March 22, 1977

These amendments relate to revised enthalpy rise hot channel factor (FAH) Technical Specifications for Surry Units Nos. 1 and 2 to account for new fuel rod bow information.

AMENDMENT TO FACILITY OPERATING LICENSE

SAFETY EVALUATION BY THE OFFICE OF NUCLEAR REACTOR REGULATION
SUPPORTING AMENDMENTS NOS. 30 AND 29 TO LICENSES NOS. DPR-32 AND DPR-37
VIRGINIA ELECTRIC & POWER COMPANY
SURRY POWER STATION UNITS NOS. 1 AND 2
DOCKETS NOS. 50-280 AND 50-281

REGION AVERAGE BURNUP (1000 MWD/MTU)
FIGURE 3.12-9 INTERIM THIMBLE CELL ROD BURNUP ON $\frac{1}{M}$ SURVEY UNITS NO. 1 AND 2

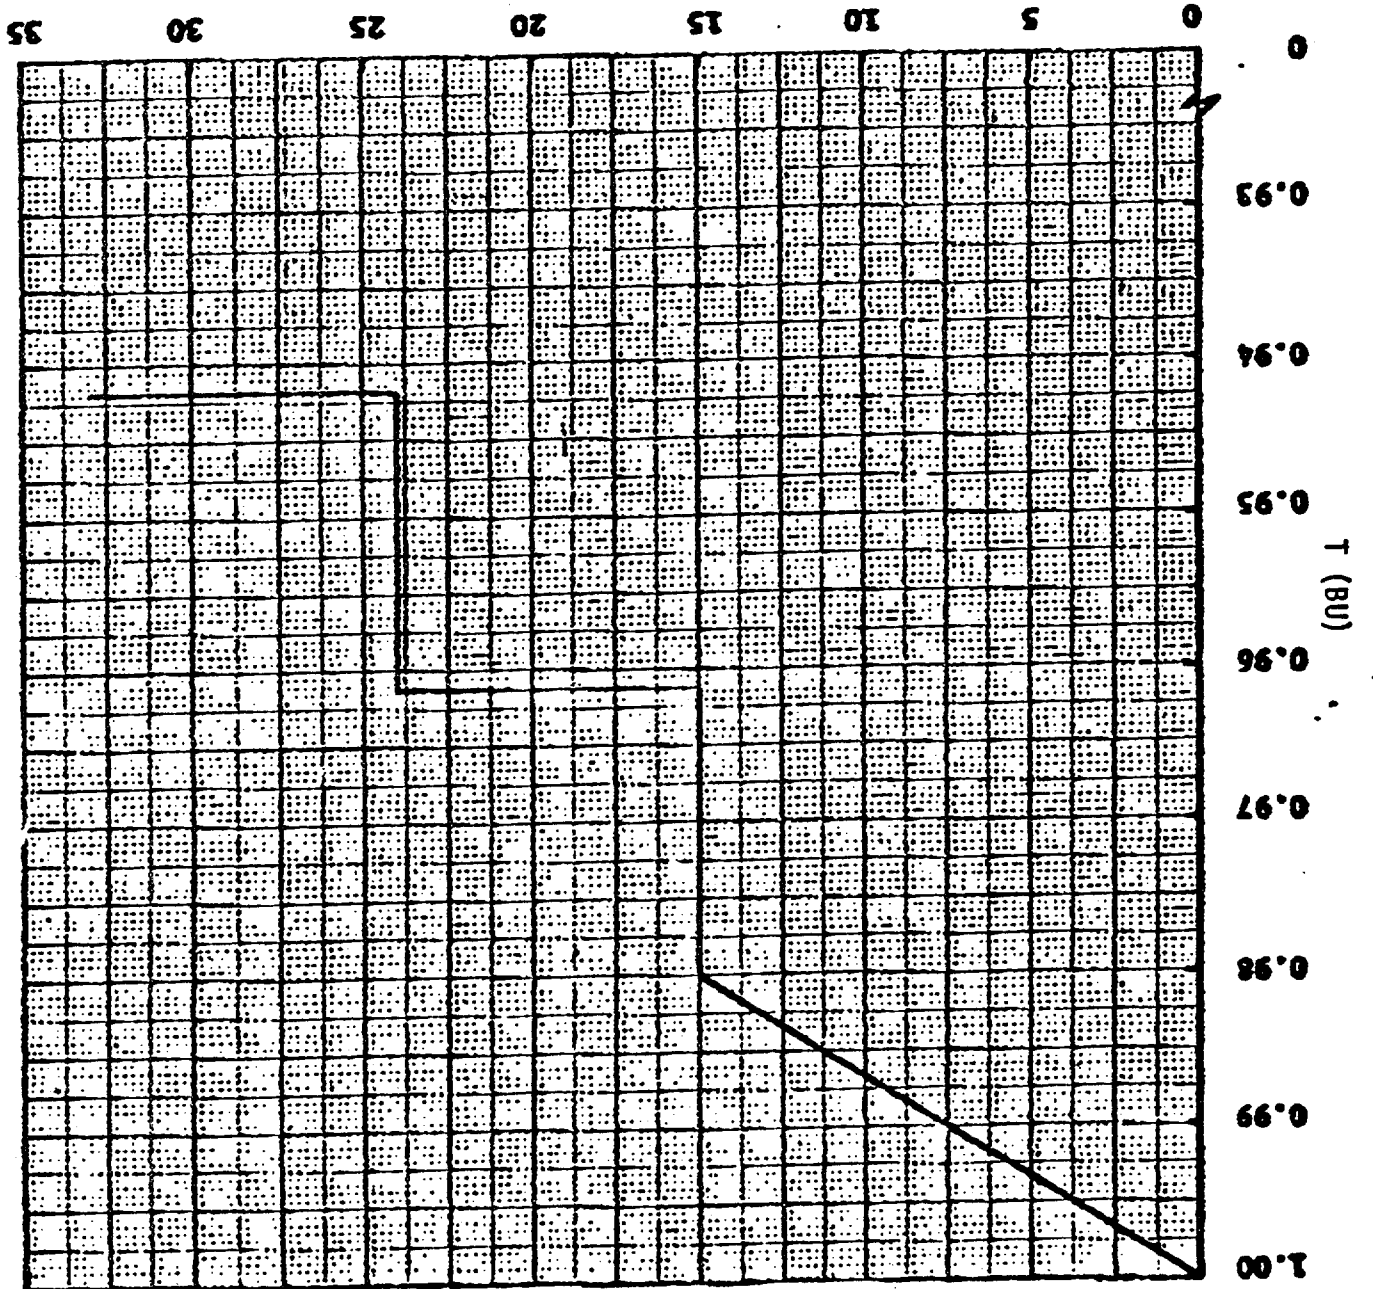
where P is the fraction of rated power at which the core is operating, K(Z) is the function given in Figure 3.12-8, Z is the core height location of F_Q, and T(BU) is the interim thimble cell rod bow penalty on F_{ΔH}^N given in TS Figure 3.12-9.

A recent evaluation of DNB test data from experiments of fuel rod bowing in thimble cells has identified that it is appropriate to impose a penalty factor to the accident analyses DNBR results. This evaluation has not been completed, but in order to assure that this effect is accommodated in a conservative manner, an interim thimble cell rod bow penalty for 15 x 15 fuel, T(BU), is applied to the measured values of the enthalpy rise hot channel factor, $F_{\Delta N}^N$. It is anticipated that the values of this penalty will change after the evaluation of the test data has been completed.

$$F_{\Delta H}^N \leq 1.55 (1 + 0.2(1 - P)) \times T(\text{BU})$$

REGION AVERAGE BURNUP (1000 MWD/MTU)
INTERIM THIMBLE CELL ROD BOW PENALTY ON
SURRY UNITS NO. 1 AND 2
FIGURE 3.12-9

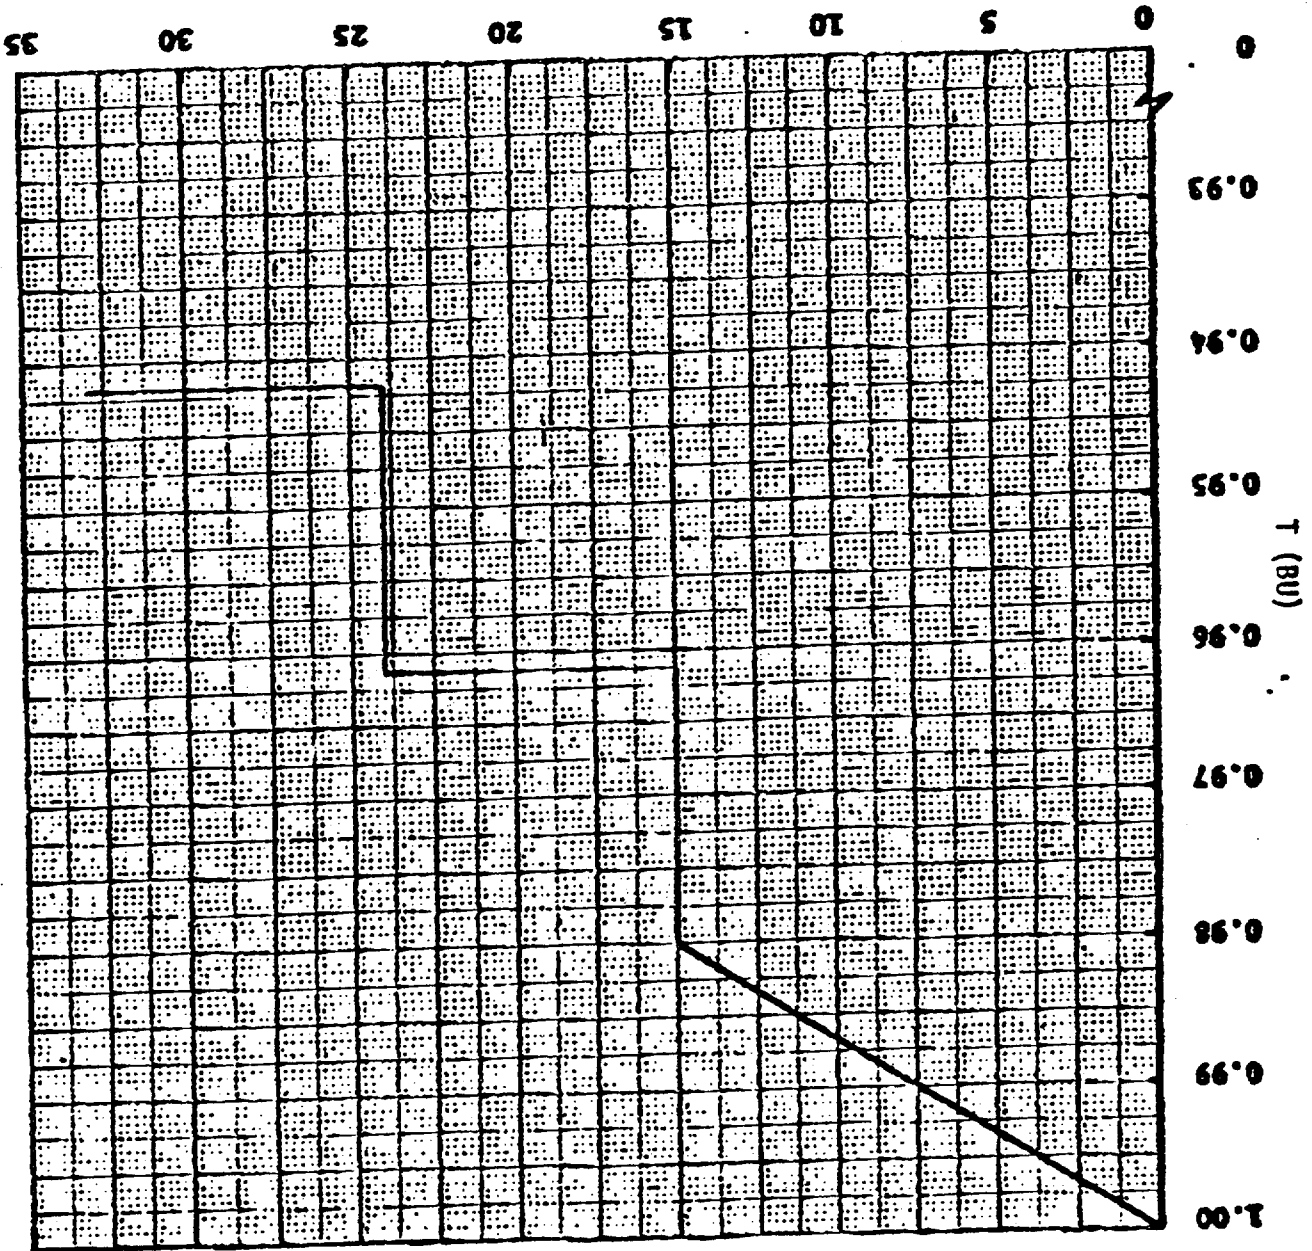
where P is the fraction of rated power at which the core is operating, K(Z) is the function given in Figure 3.12-8, Z is the core height location of F_Q, and T(BU) is the interim thimble cell rod bow penalty on F_{ΔH}^N given in TS Figure 3.12-9.

A recent evaluation of DNB test data from experiments of fuel rod bowing in thimble cells has identified that it is appropriate to impose a penalty factor to the accident analyses DNBR results. This evaluation has not been completed, but in order to assure that this effect is accommodated in a conservative manner, an interim thimble cell rod bow penalty for 15 x 15 fuel, T(BU), is applied to the measured values of the enthalpy rise hot channel factor, $F_{\Delta N}^N$. It is anticipated that the values of this penalty will change after the evaluation of the test data has been completed.

$$F_{\Delta H}^N \leq 1.55 (1 + 0.2(1 - P)) \times T(\text{BU})$$

FIGURE 2.1

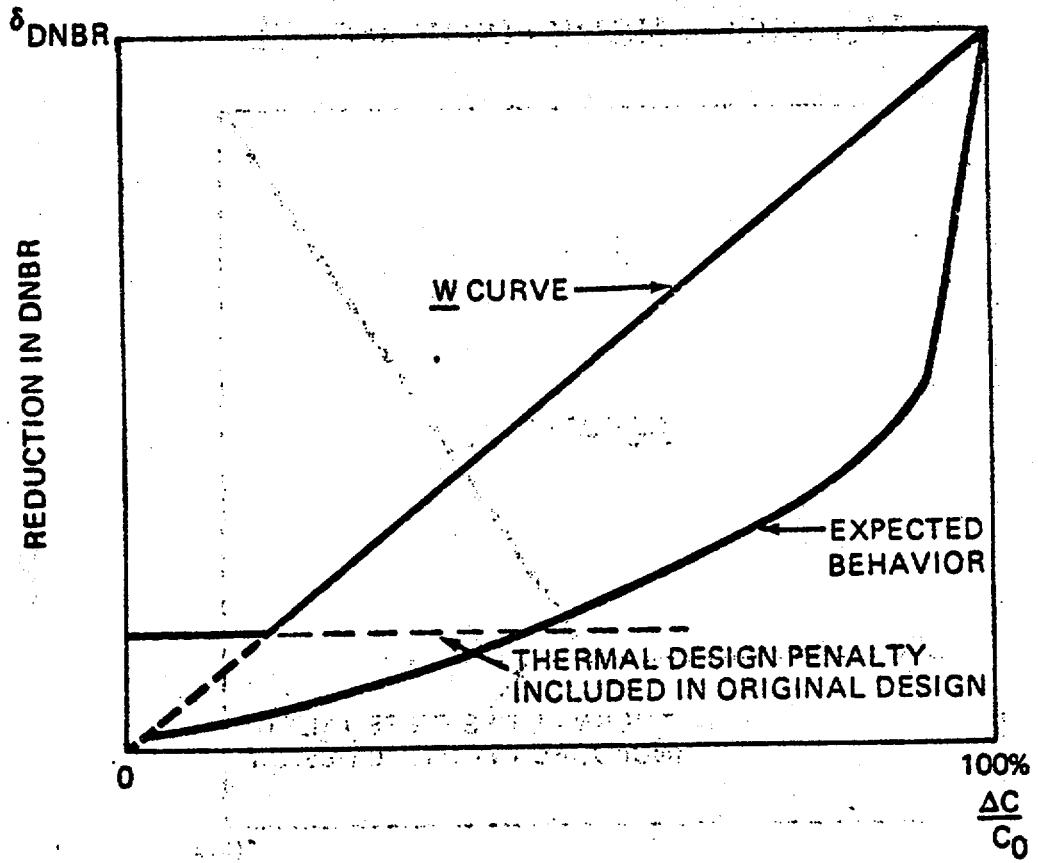
As stated in Section 2.1, data were presented by Westinghouse for the DNBR reduction at full contact and with no bow. No data at partial gap closure were presented. Westinghouse proposed, and the staff accepted, a straight line interpolation between these two points as shown in Figure 2.1.

This approach is conservative if the DNBR reduction does not increase more rapidly than the straight line reduction shown in Figure 2.1. Although the data for DNBR reduction due to rod bowing in the presence of an unheated fuel rod cannot be predicted by existing analytical methods, one would nevertheless expect that the actual behavior would more nearly follow the curved line also shown in Figure 2.1. According to this curved line, the DNBR would be reduced gradually for small amounts of bow. As the fuel rods (or fuel rod and unheated rod) become close enough so that there is an interaction, the DNBR would decrease more rapidly. No physical mechanism has been postulated which would lead to sudden large decreases in the DNBR for small or moderate gap closures. Thus, the straight line approximation is believed to be an overestimate of the expected behavior.

In developing the interim rod bow penalties described in this report, it became apparent that the penalty should be a function of burnup since the magnitude of rod bow is a function of burnup. However, to maintain existing thermal margins early in core life when only a small amount of fuel rod bow is anticipated, the initial pitch reduction factor was included until such time as the rod bow DNBR reduction became greater. This is represented as the straight horizontal line on Figure 2.1.

FIGURE 2.2

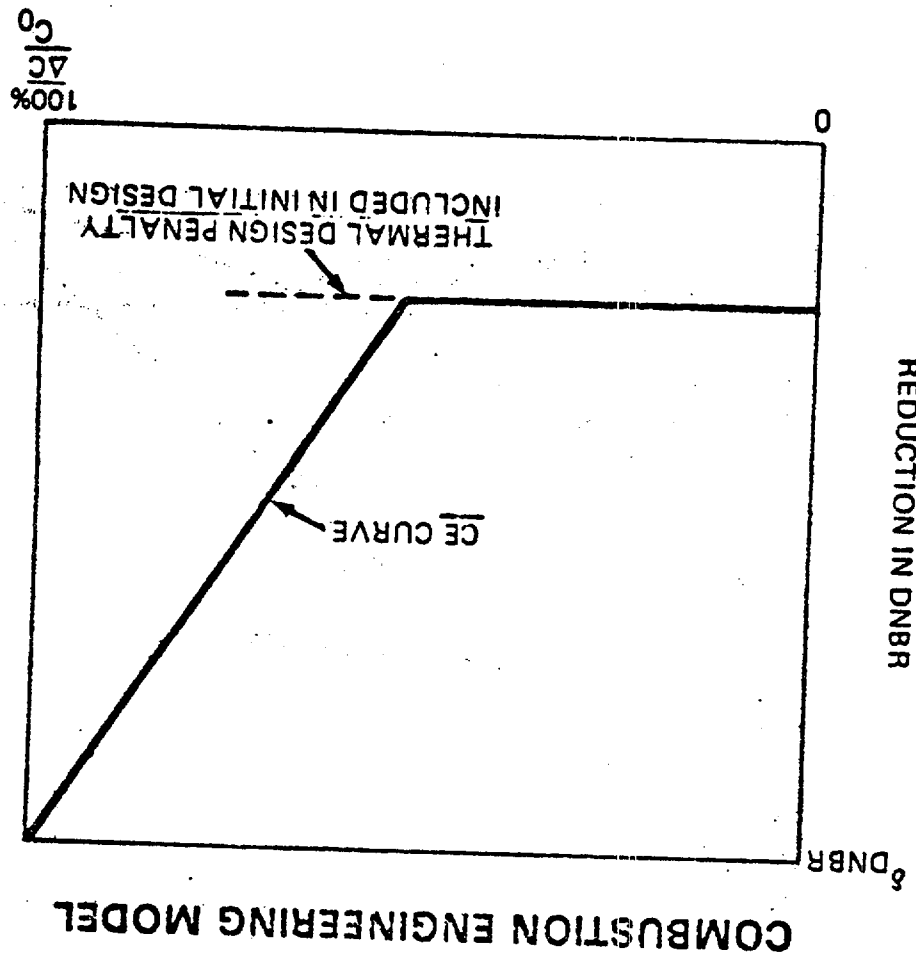
Combustion Engineering performed experiments to determine the effect of rod bowing on DNBR which included some cases in which the effect of partial bowing as well as bowing to contact was determined. Again, a straight line interpolation is used. However, the point of zero DNBR reduction is not at zero clearance reduction but rather, at an intermediate value of clearance reduction. This is shown schematically

in Figure 2.2. The horizontal straight line, representing the initial pitch reduction factor is included as explained previously in Section 2.2
